Design Review/Preservation Board
Sacramento, California

SUBJECT: 1400 E Street (PB93-040)
Exterior rehab of existing building
Washington District Preservation Area
(APN: 002-126-001)

Design Review Preservation Board Comments
Meeting October 12, 1994
1400 E Street Project (PB93-040)

SITE PLAN

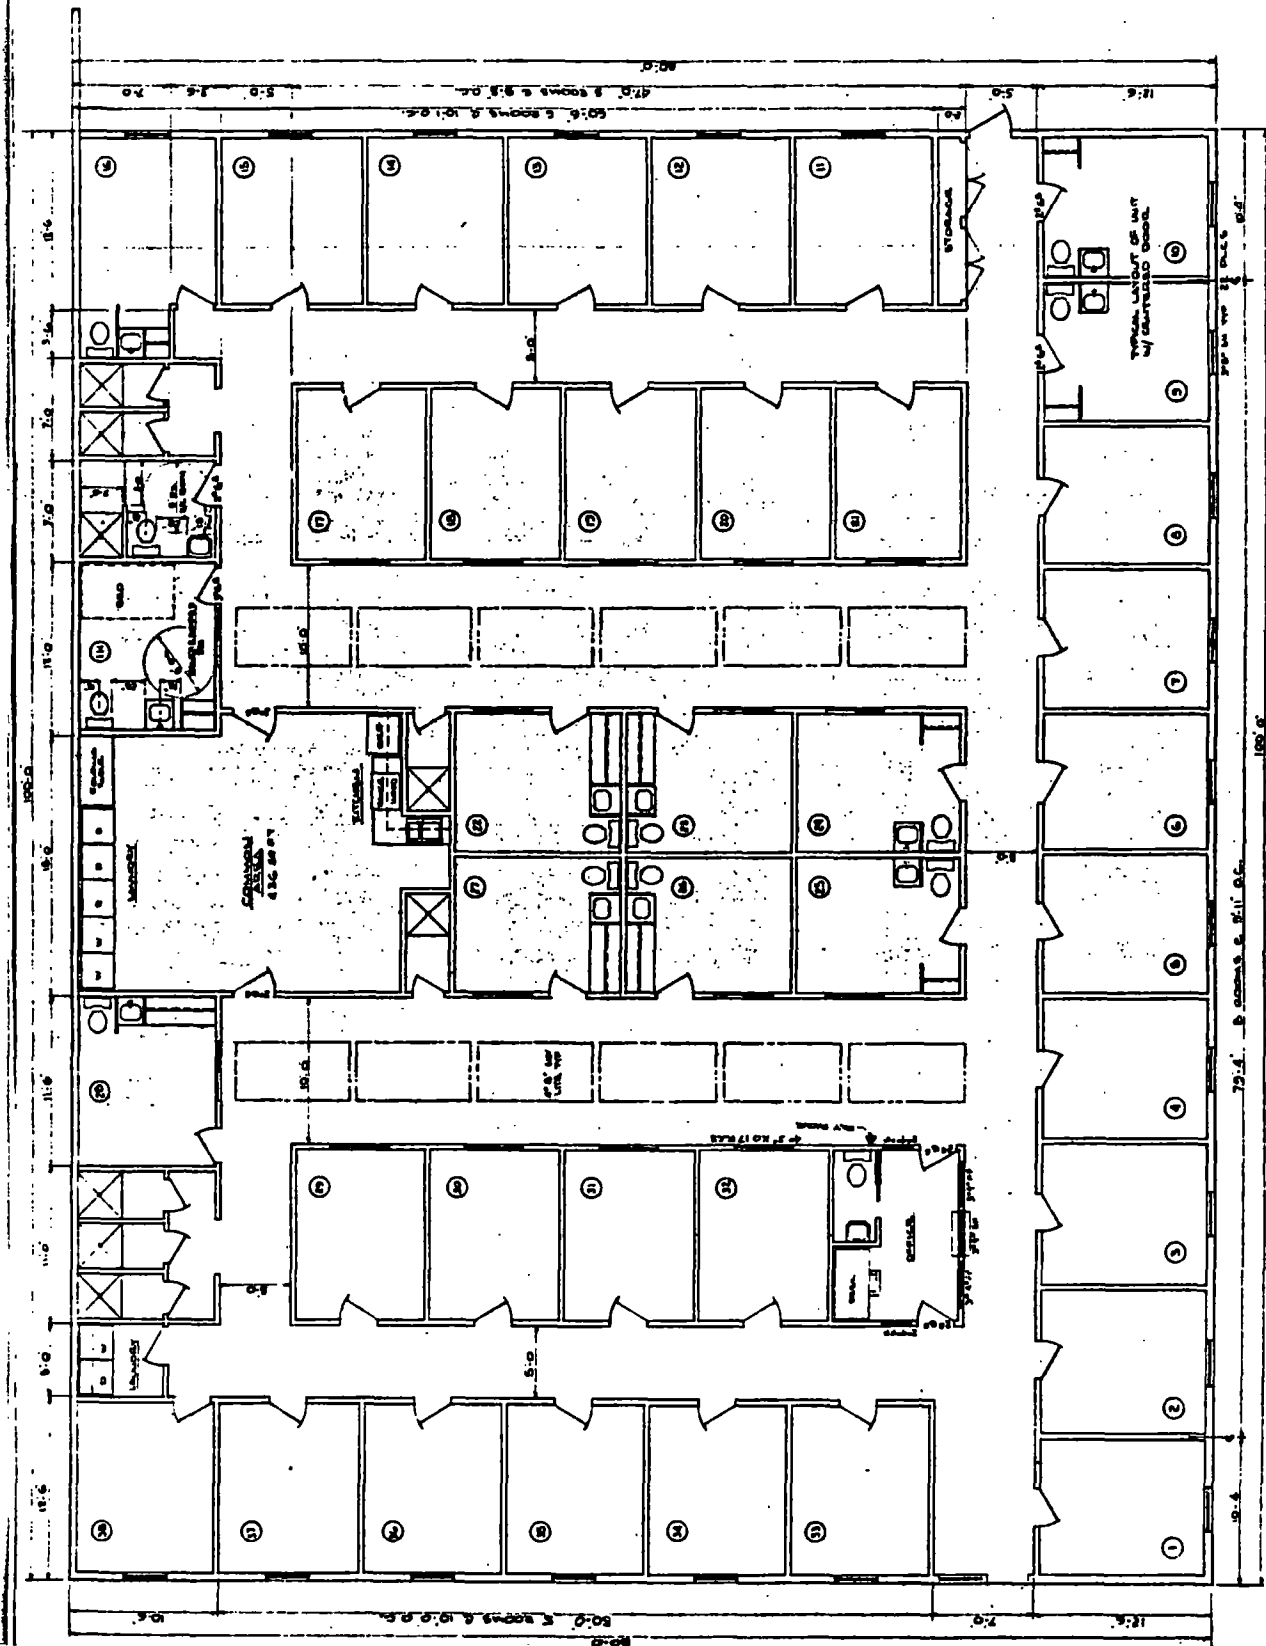
5. Parking for an SRO is 1 space per 10 occupants. Staff recommends reducing parking and replacing with an open green space for the tenants to utilize.

E. STREET INN
NORTH/WEST VIEW
SCALE 1/8" = 1'-0"

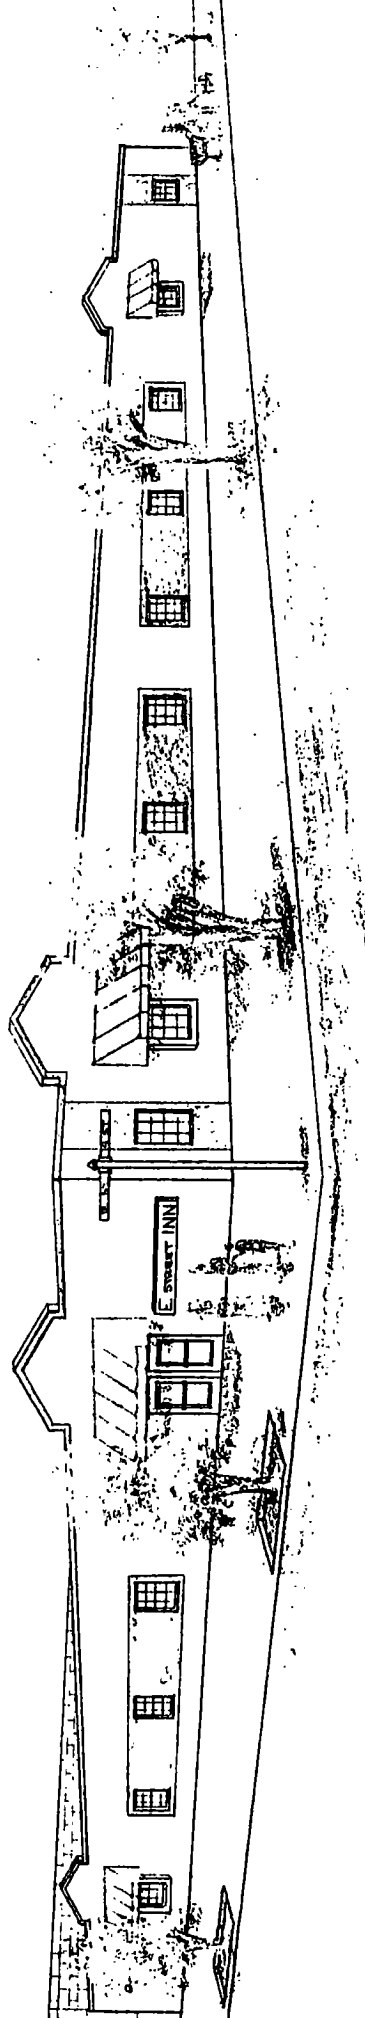
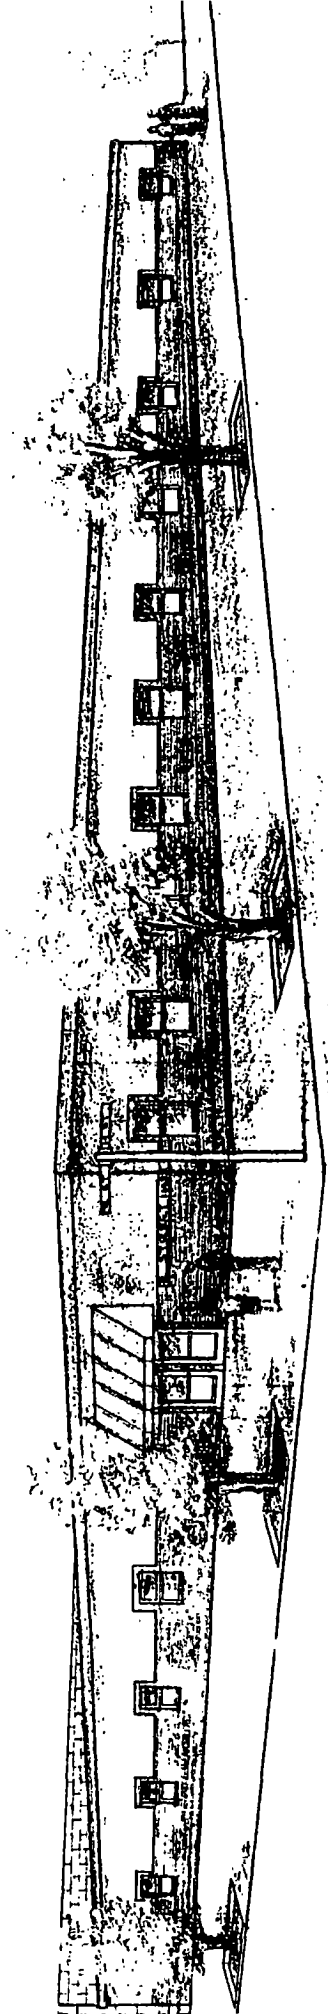
2. The elevations submitted by the applicant propose new stucco exterior with single hung metal frame windows. Staff feels the elevations do not relate to the neighborhood and could be further refined to reflect more of the residential flavor of the area. Some suggestions have been to introduce a second material such as brick or tile as a wainscot or some other design component.

3. The entrances are very understated and perhaps could be more emphasized with use of material, or appropriate signage.
4. Landscaping at the parking area should be utilized to buffer the lot from the pedestrian walkway. Staff recommends a wrought iron fence with landscaping to screen the parking. The trash enclosure should be screened from view also.

6. Detailing at the windows and cornice should be enhanced to better work with the overall design.
7. The applicant has provided additional design schemes for the Board to review and comment on at the hearing. The various schemes include the use of awnings, pedimented shapes at the parapet line, and brick wainscoting.
8. Of concern also is the rooftop equipment that may be placed on the building for the new use. Several residents look down on the property and feel this issue should be reviewed.
